# REVIEW COMMENTS

FILE # RZO-95-131

TITLE HEADING: ODP and Rezone - Horizon Village

LOCATION: SE corner 7th and Horizon Drive

**CONCEPT PLAN**

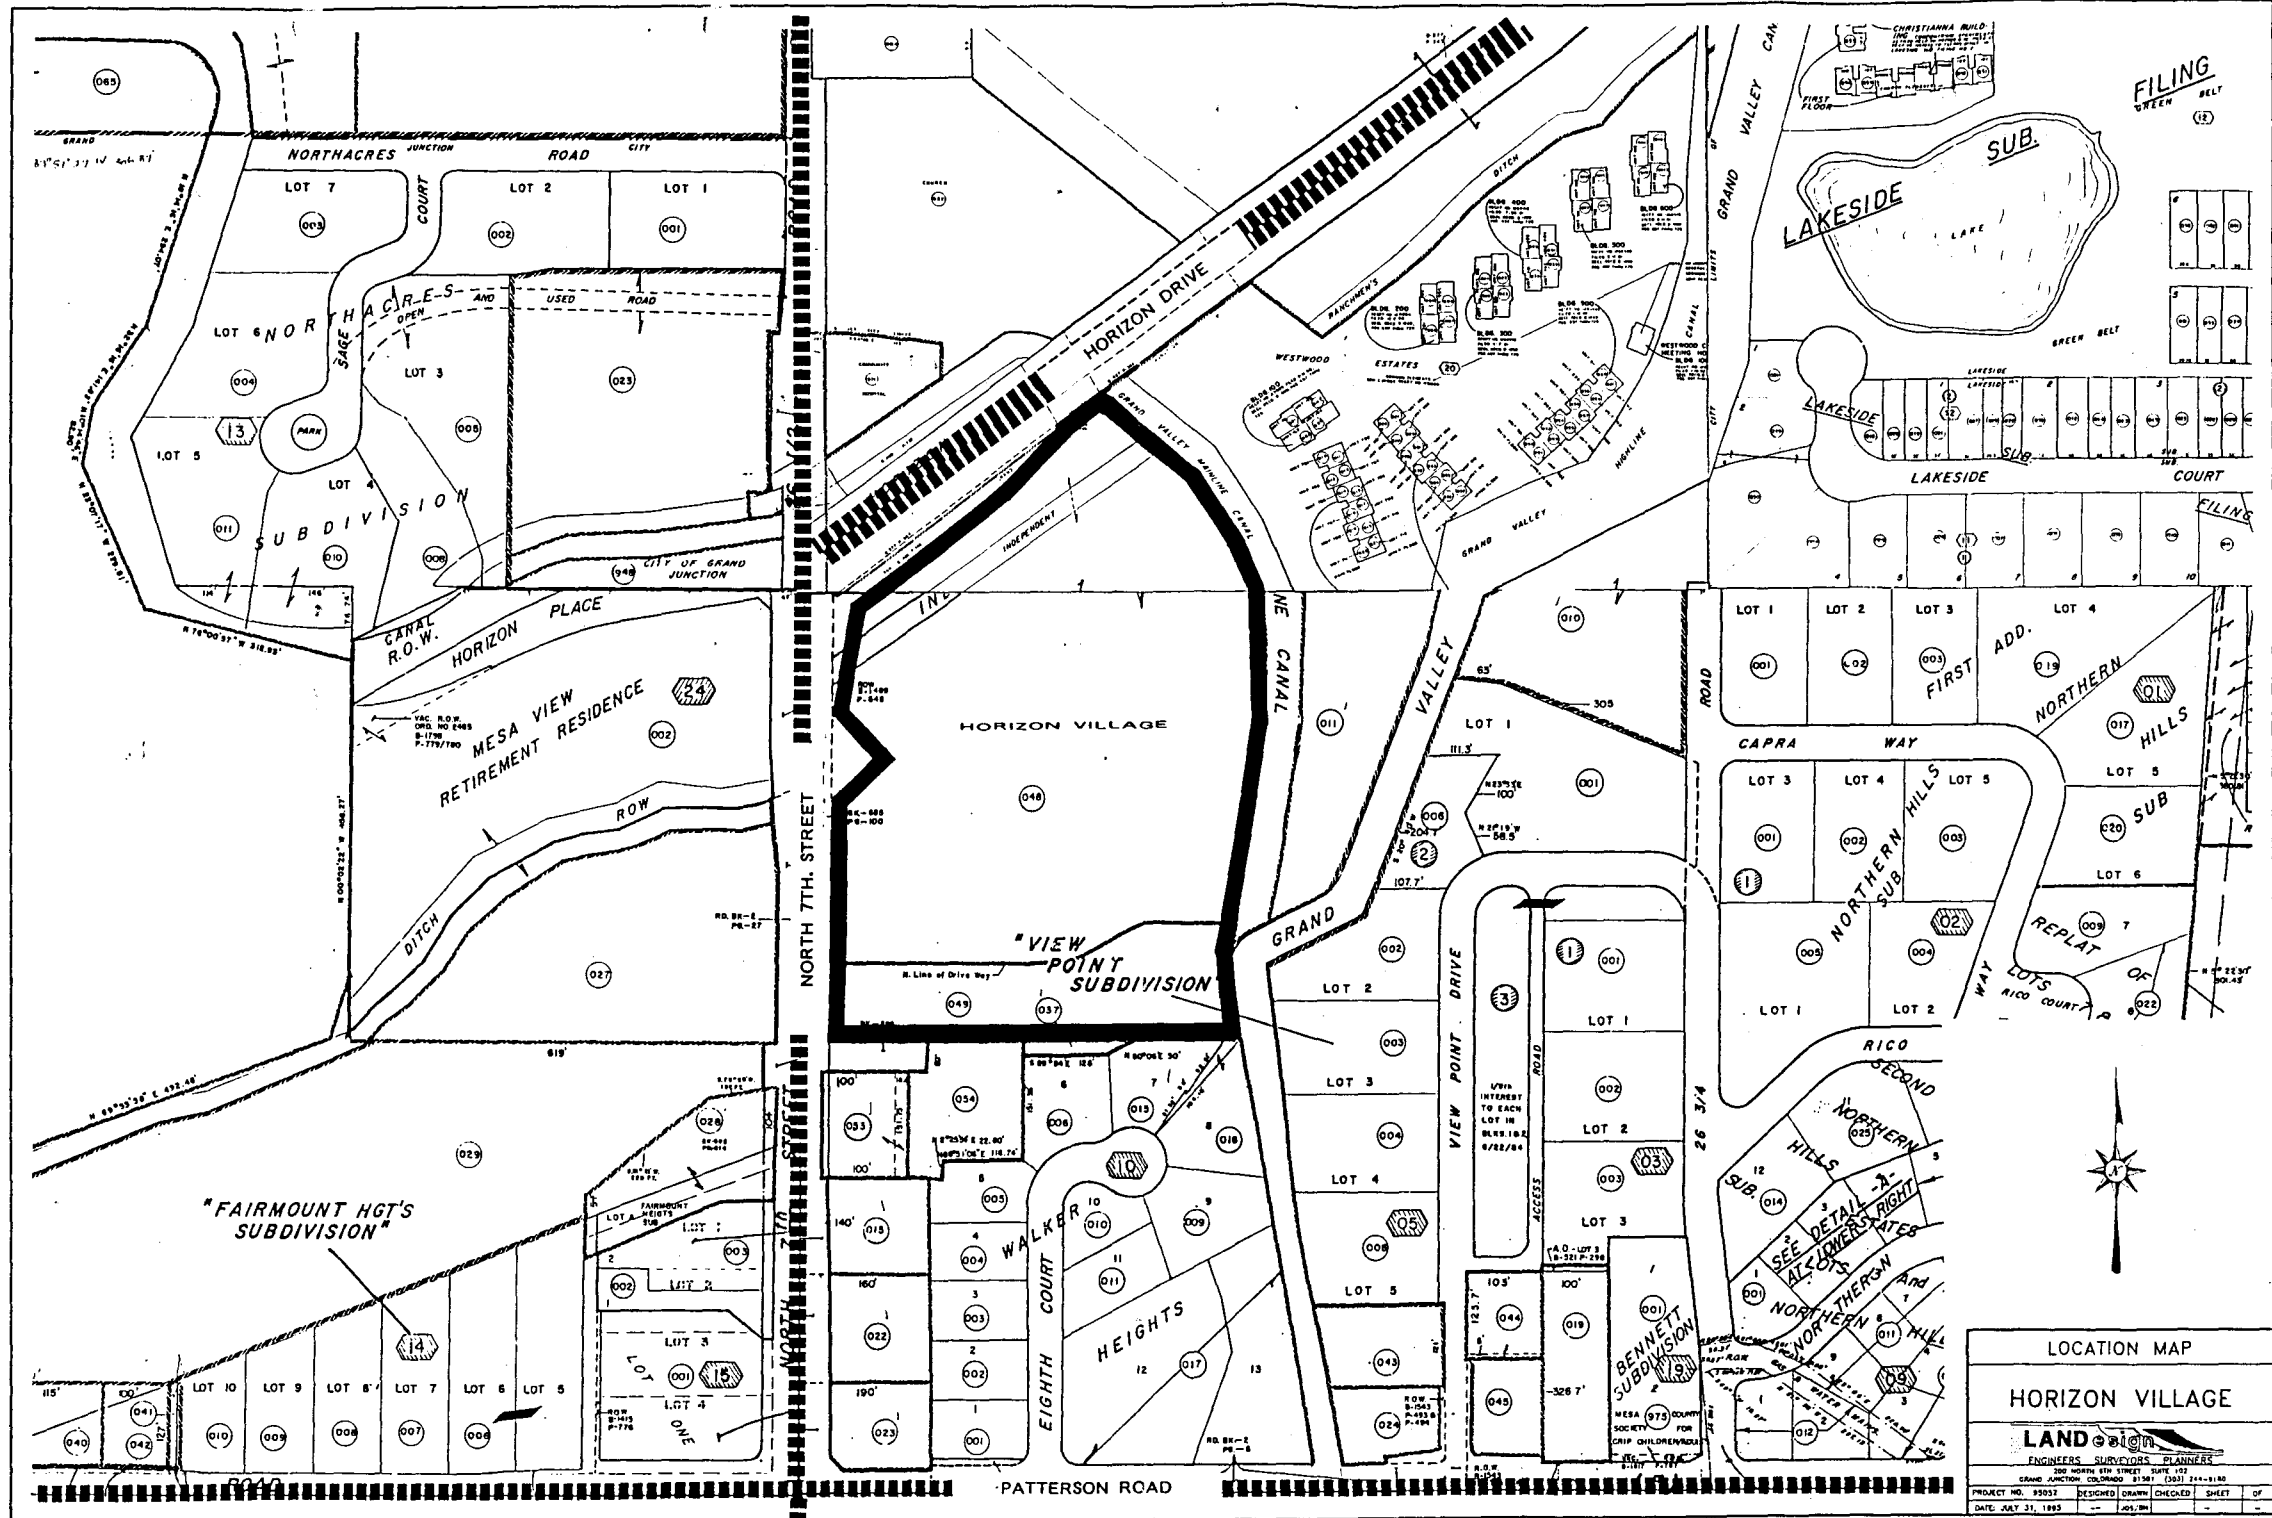
PSCO requires standard 14' front lot easements. Each building will have only one point of service for both gas and electric. Service points must be on front 1/3 of each building.

1. On-site detention will be required due to downstream concerns with the Ranchman's Ditch.
2. A traffic study which addresses the following will be required:
  - A peak hour gap analysis on 7th Street at the proposed location of the entry.
  - A signal timing analysis if there are insufficient gaps to allow left turns from the site.
  - A measurement of sight distance on 7th Street from the proposed entry.
  - An evaluation of the need for a right turn lane into the site.
3. The private drive as proposed to serve four lots does not meet City Code. A standards city street section is required.

The City of Grand Junction would prefer the existing 15" sanitary sewer line be located within a proposed roadway.

RESPONSE TO UTILITY ENGINEER: Locating the existing 15 inch sanitary sewer in a separate easement adjacent to the road right-of-way would allow the following:

- a. Since the integrity of the sewer main is not known, potential damage to the existing main might occur during the street construction. Locating the main outside of the street should minimize any disturbance to the existing sewer line.
- b. Would allow a stand of trees to remain undisturbed. The applicant would like to use the existing trees as a buffer between the street and the planned units.
- c. Access to the existing manholes would be accomplished by placing the planned access drives over the manhole location.

1. A detailed drainage analysis will be conducted as part of the preliminary and final plan process. If it is determined that storm water detention is necessary, there is sufficient open areas within the development to accommodate a storm water management facility. Past experience with neighboring development has shown that storm water detention is not required do to the location of the development within the overall drainage basin for the Ranchman's ditch.
2. A traffic study will be completed in accordance with the City's *Submittal Standards for*

3. A plan depicting the lot configuration has been transmitted to the Community Development Department. The new plan indicates Private Landscaped Open Space for the area in the center of the development. The open space is intended to be used as an open play area.

4. During the preparation of the preliminary and final plans other alternatives will be explored from the private drive which was planned to serve the existing single family site and the proposed three lots. A preferred option would include modification of the plan as submitted. The modification would combine the existing home site lot with the adjacent lot to the east, and providing a short cul-de-sac without on street parking and sidewalk on one side from the planned entrance road to the three reconfigured single family lots.

CONCEPT PLAN

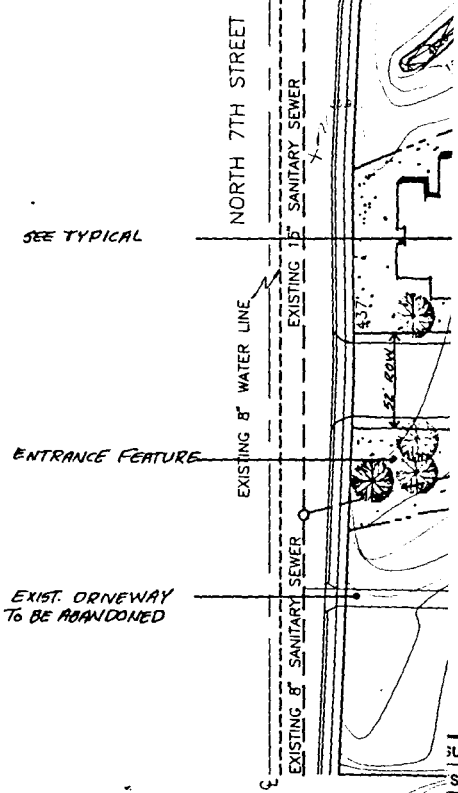
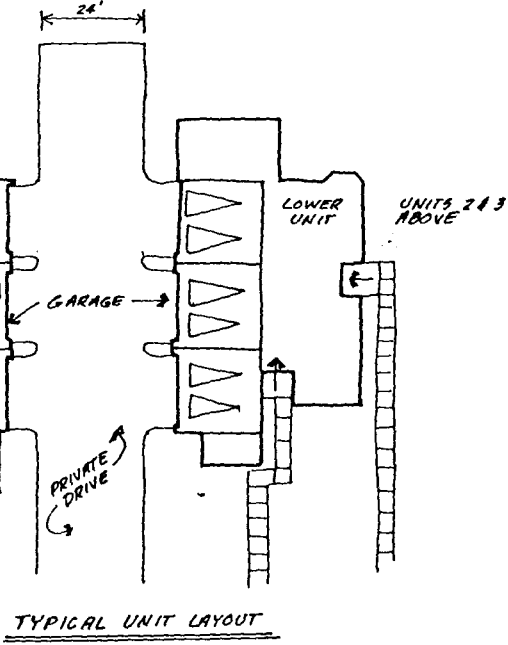
This letter is in regards to review comments for Horizon Village. According to the review comments from Trent Prall, City of Grand Junction Utility Engineer, he is concerned over the location of the existing sanitary sewer line in relation to the proposed road. It was our desire to speak with Trent before the Planning Commission hearing on September 12. Unfortunately, we have been informed that Trent is out of town and we will not be able to speak with him before the hearing.

There are four reasons why we placed the road offset from the existing sanitary sewer line;

1. Moving the proposed road directly over the existing sewer line will shorten the sight distance for the people exiting from the development significantly.
2. Moving the proposed road will also force the location of the townhomes southward. This will mean the buildings will be located on or near slopes approaching 20%.
3. A large grove of trees is located to the south of the proposed townhome's location. If the townhomes are moved to the south, the trees will need to be removed.
4. The existing sanitary sewer line is known be old, and minimal disturbance to this line may be desired.

Where the sewer line is currently located on the plans, it should be noted that sufficient easement will be provided for maintenance and other activities that are involved with the sanitary sewer line.
